Access Report

Homes NSW – Tweed Heads
25-27 Boyd Street
Tweed Heads NSW 2485

For: CKDS
Ref: PAA_22478

Development application documentation for the proposed Homes NSW – Tweed Heads project, located at 25-27 Boyd Street, Tweed Heads, has been reviewed against current accessibility legislation.

Figure 2 | Site Plan

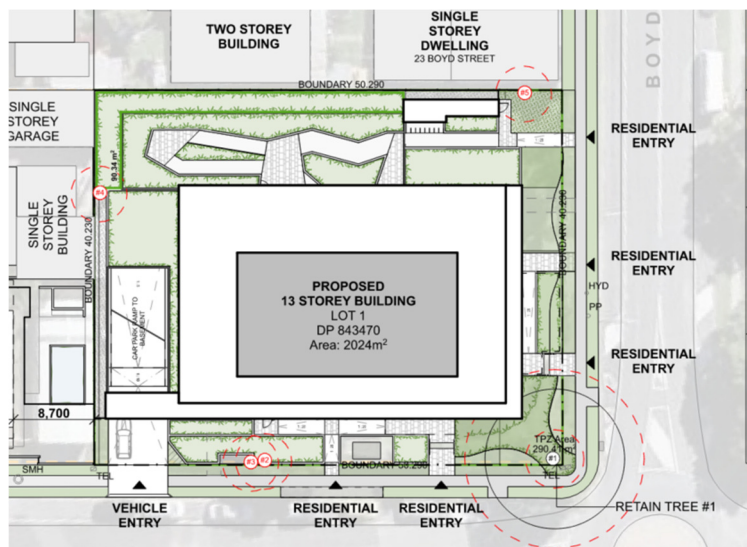
An accessible path of travel is provided to the building entrance from the allotment boundary along Boyd Street and Brett Street via formed footpaths and 1:20 walkways. On-grade access is achievable.

Stairs are provided as a part of the pedestrian access from both Boyd Street and Brett Street to the building entrance.

The overall configuration of the stairs achieves compliance with current legislation including handrails both sides and tactile indicators top and bottom.

We note stairs are setback at least 900mm from the allotment boundary to allow for handrail extensions and TGSI.

Ensure provision of contrasting non-slip nosing to treads during detailed design.

Two (2) 1:20 walkways are provided, fronting Boyd Street and Brett Street and offer accessible paths of travel to the building.
